Oakland City Planning Commission STAFF REPORT

Case File Number CM10-140 **August 4, 2010**

Location:	**Skyline Boulevard (north of Chabot Space & Science Center street entrance)**
Assessor's Parcel Number:	**None**
Proposal:	To install a 36'-4"-tall Monopole Telecommunications Facility in the public right-of-way along Skyline Boulevard.
Applicant/ Phone Number:	Sharon James / NextG (for Verizon) (408) 426-6629
Owner:	City of Oakland
Planning Permits Required:	Major Conditional Use Permit with 2 sets of additional findings to allow a Monopole Telecommunications Facility in the OS Zone (OMC Sec. 17.11.080, 128.080(C), 134.020(A)(3)(f))
General Plan:	Urban Open Space
Zoning:	OS (RSP) Open Space (Region-Serving Park) Zone
Environmental Determination:	Exempt, Section 15270 of the State CEQA Guidelines: Projects Which Are Disapproved
Historic Status:	No Historic Status (vacant portion of public right-of-way)
Service Delivery District:	IV – San Antonio/Fruitvale
City Council District:	4 – Quan
Date Filed:	June 3, 2010

Staff Recommendation:	To deny the application
Finality of Decision:	*Appealable to City Council within 10 days*
For Further Information:	Contact case planner **Aubrey Ros

SCALE: N.T.S. PROPOSED PHOTO / EQUIPMENT REPRESENTATION F

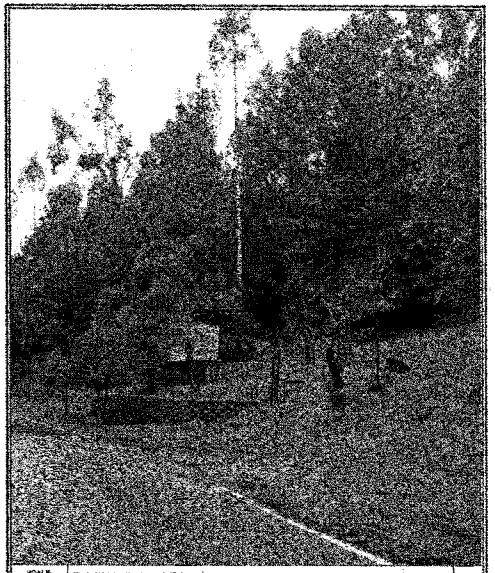
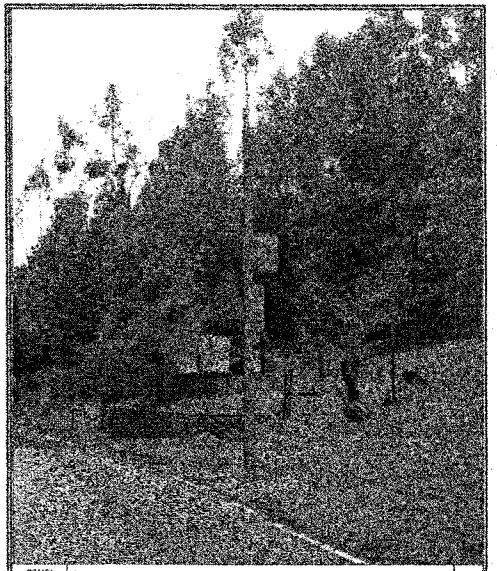
This finding cannot be made: the proposed Monopole would not be compatible with the surrounding open space/region-serving park area, would contain unsightly attached equipment, and would be excessively tall and bulky in comparison to the minimal examples of man-made structures found in the area. The design of the tall pole with attached equipment along a scenic stretch of Skyline Boulevard that is unencumbered by similar man-made structures (including power poles and light standards) will adversely affect the neighborhood character. Manmade objects in the vicinity are essentially limited to necessary No Parking signs, a trail fence, and a regional park sign, which are much smaller than the proposed 41'-5"-tall Monopole.

relatively bulky as it would contain equipment and the area does not contain any other large poles such as light standards, telephone or power poles, or telecommunications facilities such as monopoles.
